SUNDRY NOTICES AND REPORTS ON WELLS

MCA Unit #41

CURRENT (11/94)
MCA NO. 41

PROPOSED
MCA NO. 41

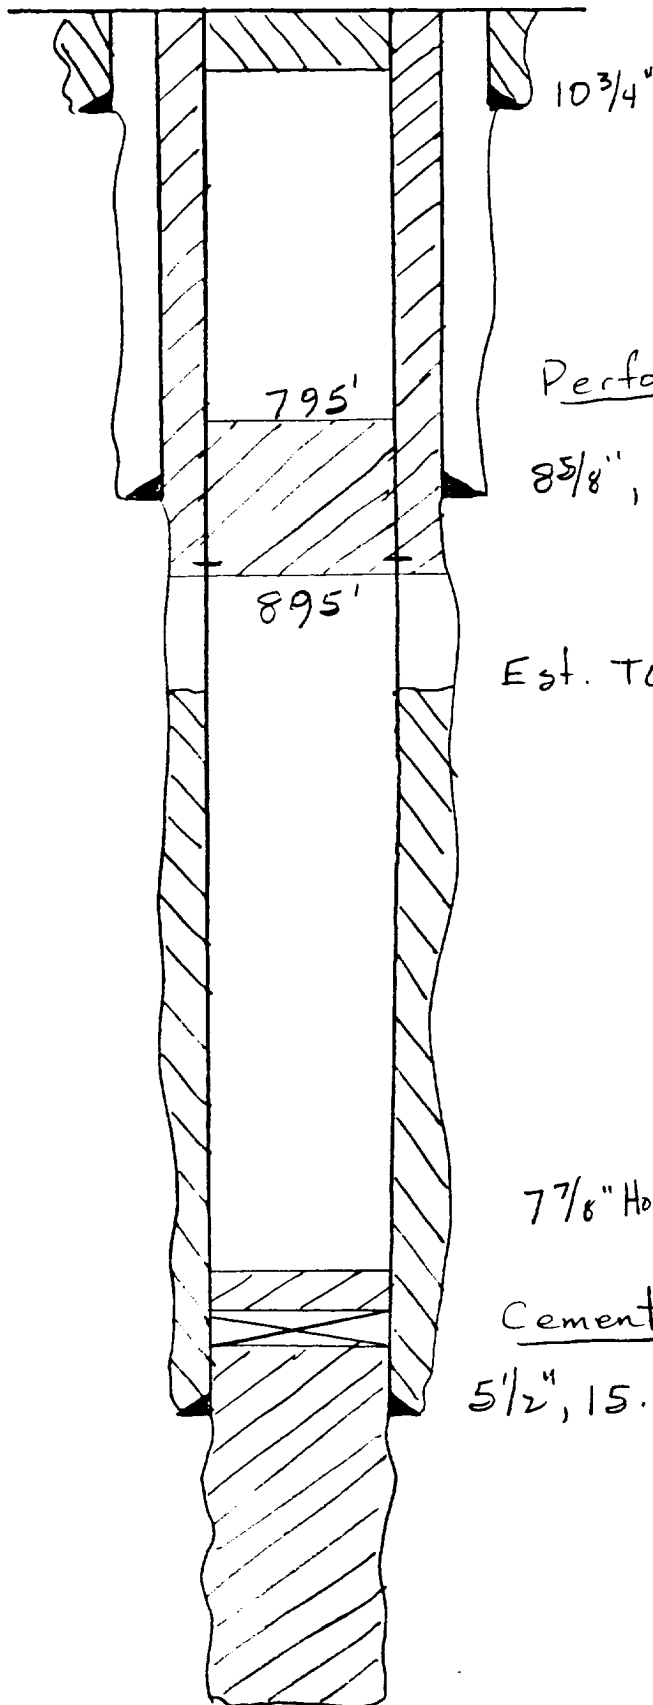
See attached. Also spot cement between 8 5/8" & 10 3/4" @ surface plug.
